RE: Autumn Wood Farms Arm O.F. Henley Drain

RE: O.F. Henley Drain-Autumn Wood Farms Arm

Re: O. F. Henley Drain, Autumn Wood Farms Arm

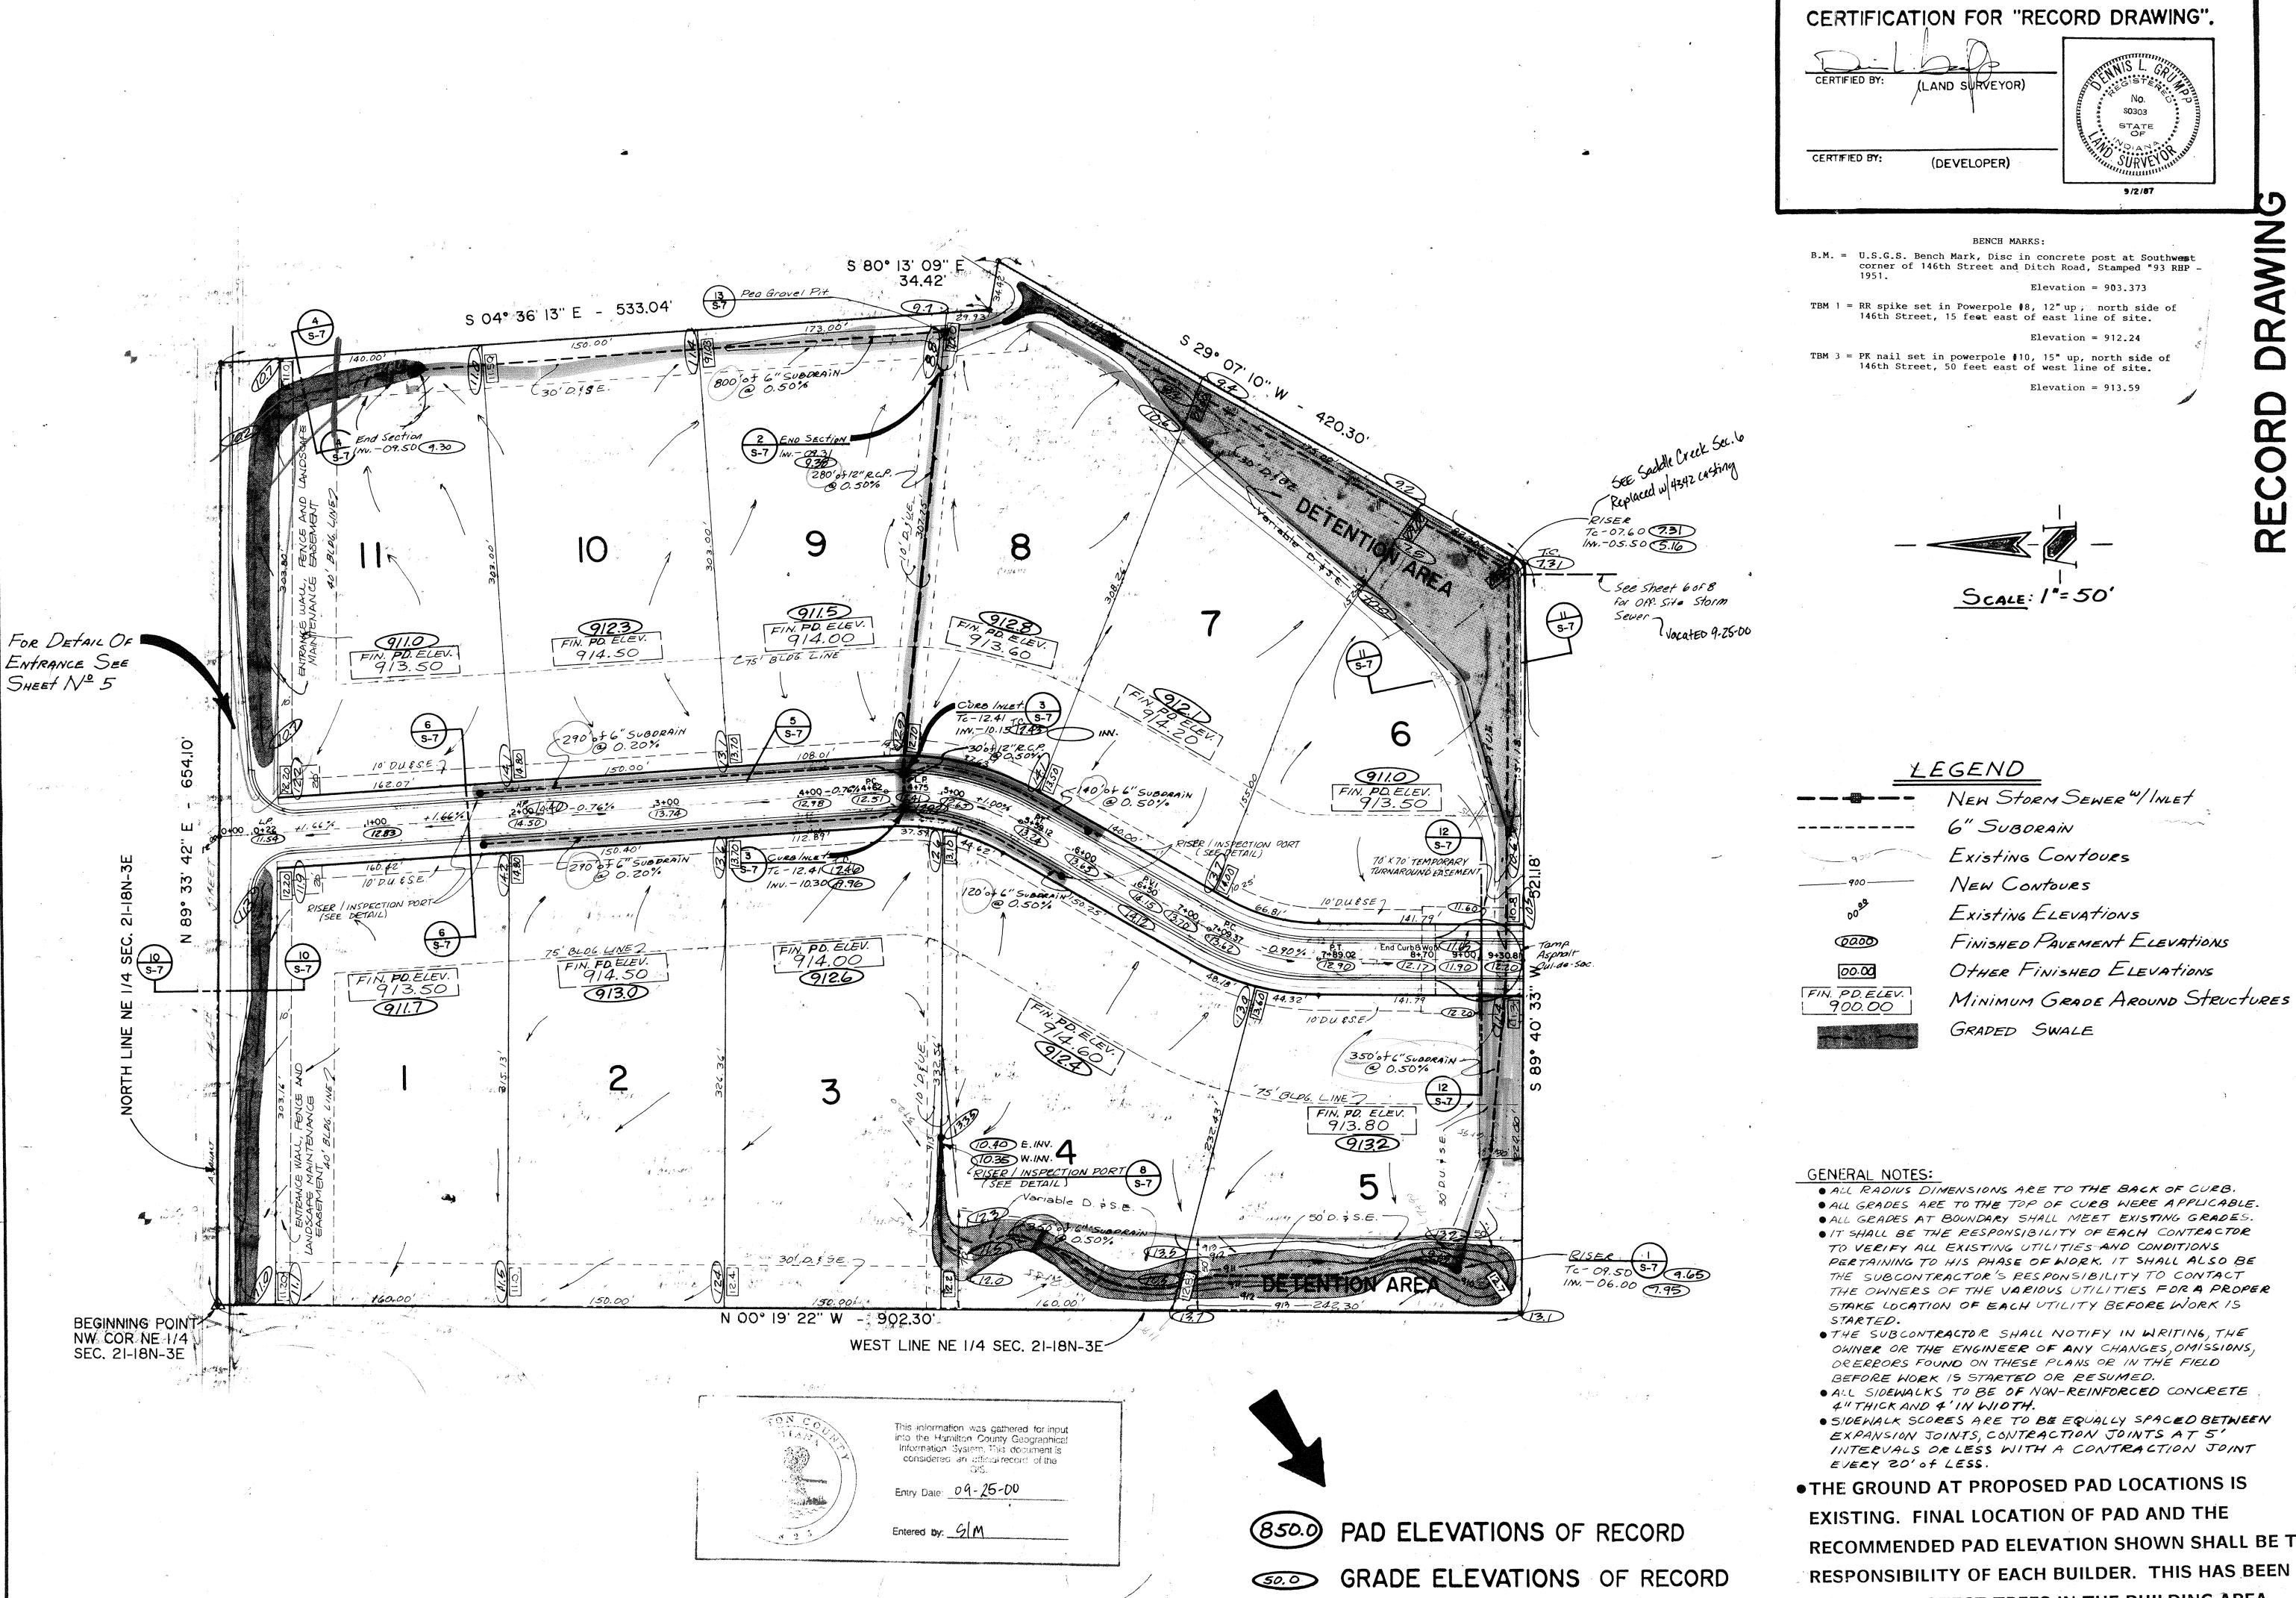
Only one slight change was made during the construction of the drain. located at the point the twelve (12") inch concrete tile from the North turned East and ran along the North side of 146th Street was omitted. This was done because the line is approximately twenty (20') feet North of the Right of Way and twenty (20') feet East of the North South fence. Because of that the riser would have been in the way of the flarm operation.

The total length of new drain is 8095 feet. However, since 2040 feet of the new twelve (12") inch concrete pipe parallels the existing tile on the Schwegmen property; only 6055 feet of drain will be added to the total drain length, which differs with my original report dated March 6, 1987.

*At this time I recommend the Board approve the drainage facilities as constructed. The nonenforcement request for this plat was approved by the Board /at/ it/s June /8, 1987 meeting.
